**THE COMPTROLLER GENERAL
OF THE UNITED STATES
WASHINGTON, D. C. 20548**

FILE: B-186543

MATTER OF: Dominion Engineering Works, Ltd., et al.

FIGURE 1
SIMPLIFIED ILLUSTRATION OF KAPLAN TYPE TURBINE
(CHANNEL BOUNDARIES AND FOUNDATION SHOWN CUT AWAY)

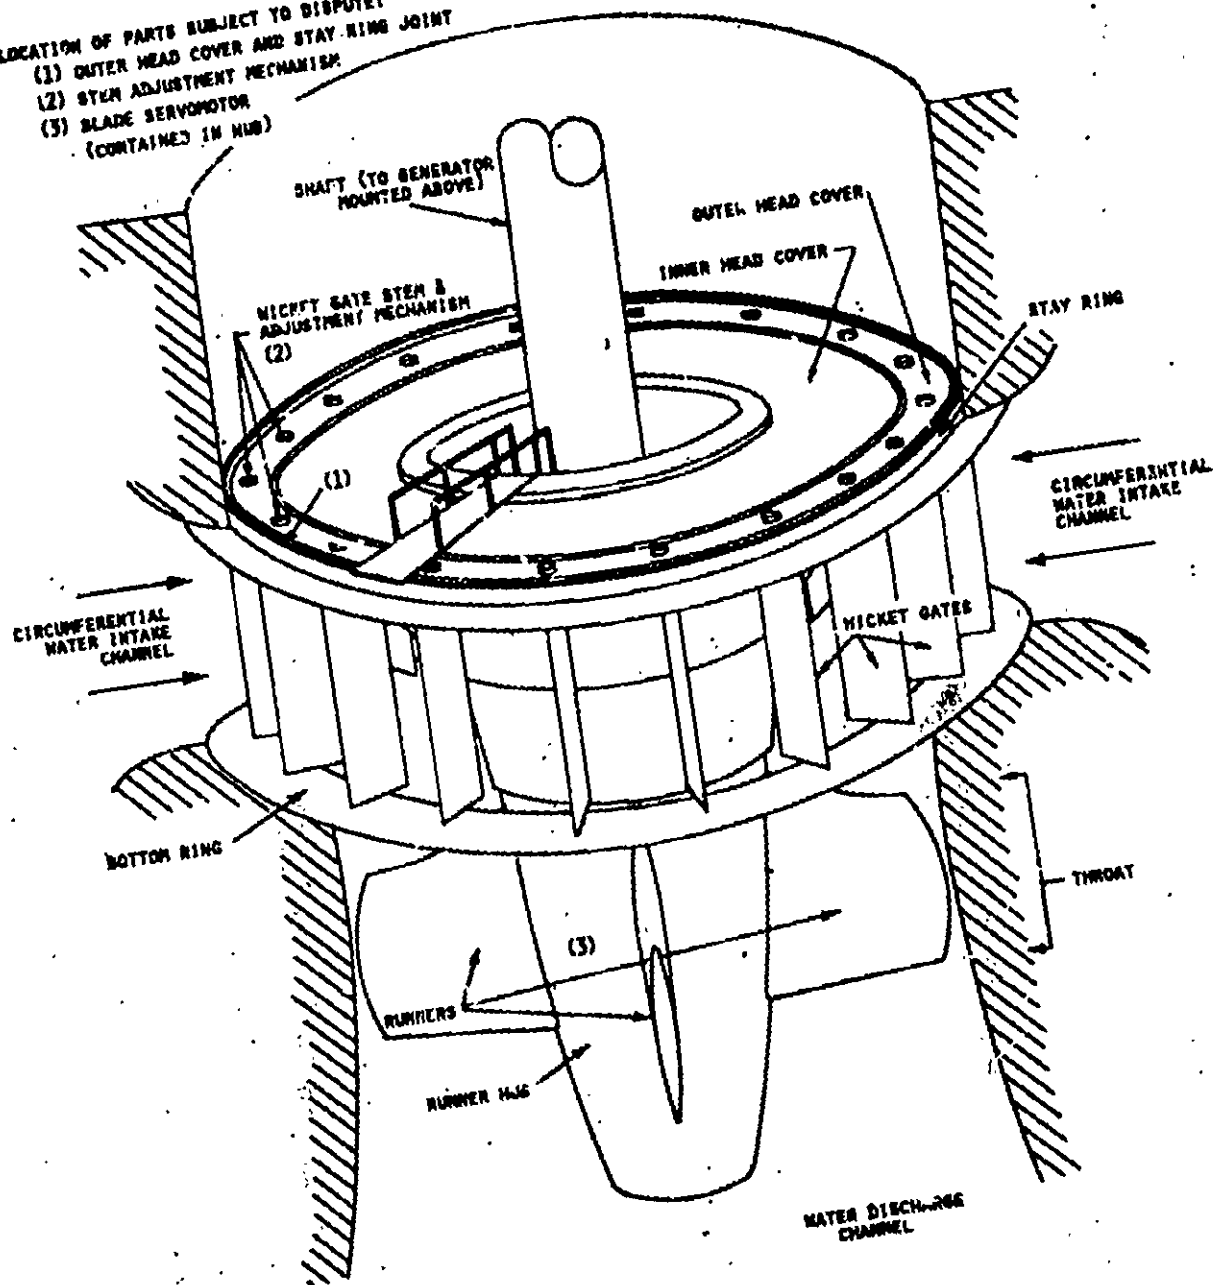
Both the Allis-Chalmers and Dominion Engineering initial bids were rejected because the Corps found that their respective bid drawings failed to allow for inclusion of radial bolts and filler plates at the joint connecting the turbine's outer head cover and stay ring. The Dominion Engineering bid was found to be non-responsive, further, because (1) its bid drawing appeared to require partial disassembly of the turbine's wicket gate stems in adjusting wicket gate height, and (2) its design failed to show three required oil seal rings, an omission which the Corps believed might require extension of the runner hub. The protesters dispute these findings. (The location of these points of dispute are indicated in the illustration.)

LOCATION OF PARTS SUBJECT TO DISPUTE:
(1) OUTER HEAD COVER AND STAY-RING JOINT
(2) STEM ADJUSTMENT MECHANISM
(3) BLADE SERVO MOTOR
(CONTAINED IN HUB)

FIGURE 2(A)
BOX-LIKE HEAD COVER & STAY RING ASSEMBLY

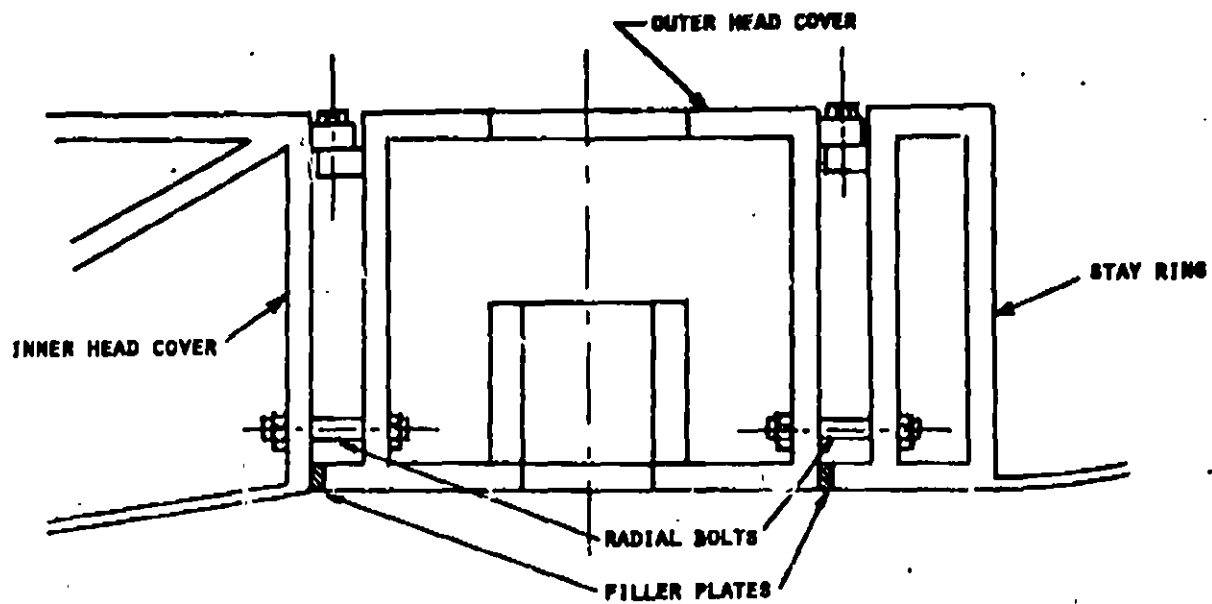
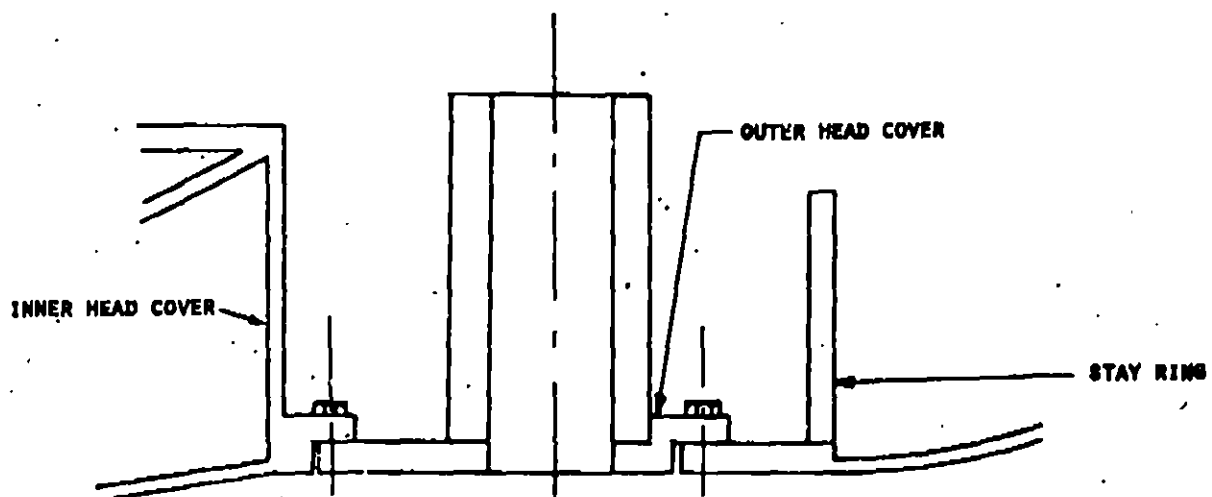
According to the explanation given by the Corps' technical personnel at a protest conference held in our Office on September 9, 1976, the Corps had experienced considerable difficulty in prior installations, where a simple lip-type joint was used. Such a joint (depicted in figure 2(B)) allows more than an acceptable amount of flexing at the joint. This deformation interferes with the proper functioning of the wicket gates, because it results in distortion of the outer head cover, housing the wicket gate stems.

In the Corps' rejection letters dated August 10, 1976, Dominion Engineering and Allis-Chalmers were advised respectively that their bid drawings indicated the use of a design which placed a circumferential bolting ring at the bottom of the outer head cover, eliminating "the box section construction." A box or box-like section construction is illustrated in figure 2(A), based on the Corps' explanation at the protest conference. The relevant portions of the Dominion Engineering and Allis-Chalmers bid drawings are shown in figures 3(A) and 3(B).

"It has been determined that the requirements of 2-13 do not specifically dictate the arrangement described in our 10 August letter. Alternate designs are acceptable [for purposes of resolicitation] provided that the requirements for rigidity are met using the specified radial bolts and filler plates."

FIGURE 3(A)
PORTION OF DORINION ENGINEERING BID
DRAWING SHOWING HEAD COVER AND STAY
RING JOINTS

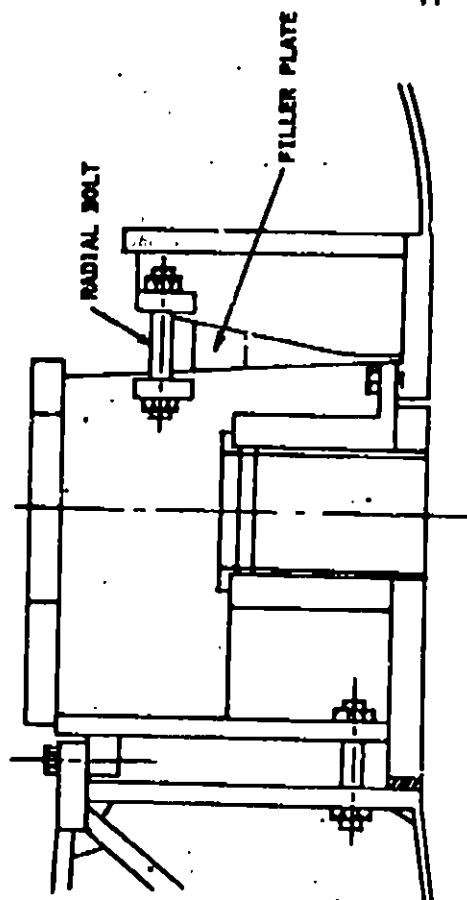
the top and bottom of the outer head cover, to allow space below to install the required radial bolts and plates.¹ Based upon the Corps' assumption that a particular geometrical relationship was required between these parts, the Corps found the Allis-Chalmers and Dominion Engineering bids nonresponsive, because it concluded that their proposed designs left the outer head cover/stay ring joint free to flex about a simple lip.²

While we are satisfied that both Allis-Chalmers and Dominion Engineering intended to fully comply with their view of the specifications' requirements, the details of their intended connection of the outer head cover and stay ring were omitted from their bid drawings. Both have since submitted drawings showing additional detail. (See figures 3(C) and 3(D).) The additional drawings indicate the use of radial bolts and filler plates.

It would appear that the failure of the drawings to show the required bolts and plates was not dispositive, of itself. The specifications required that bolts and filler plates also be utilized in the joint between the inner and outer head covers. As indicated in figure 3(A), the Dominion Engineering bid drawing showed what might have been intended to be a horizontal bolt line between the inner and outer head covers. The Allis-Chalmers bid drawing (figure 3(B)) shows no bolt center lines. Both bidders' drawings show the box-like design at this point, and the responsiveness of their designs as to that aspect was not questioned.

"* * * this drawing still does not comply with the specifications since the flanges upon which the radial bolts are attached and the bolts themselves would still flex under the strenuous vertical forces involved, allowing the entire connection to flex, and thus still not providing a rigid assembly as required by the specifications. The design proposed by Dominion would have cost considerably less than the design required by the specifications and was accordingly considered a major deficiency. * * *"

FIGURE 3(A)
PORTION OF ALLIS-CHALMERS BID
DRAWING SHOWING HEAD COVER AND STAY
RING JOINTS

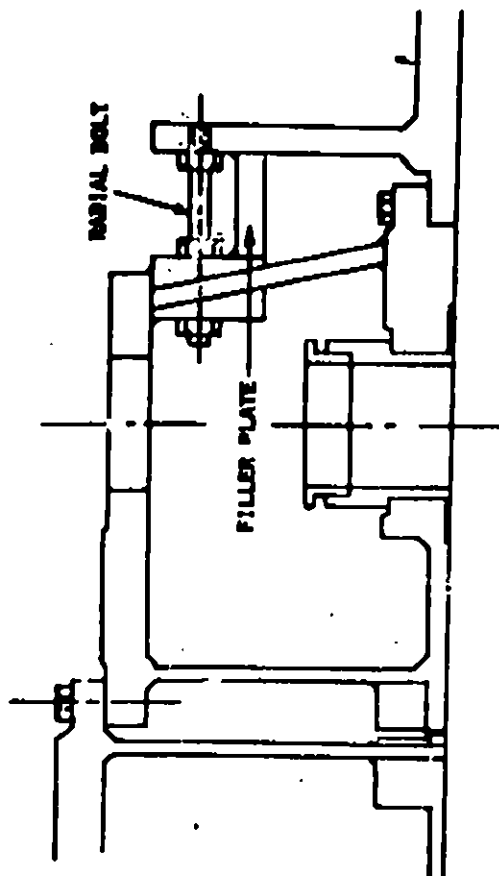
A similar objection is raised against the design shown in the Allis-Chalmers supplemental drawing.
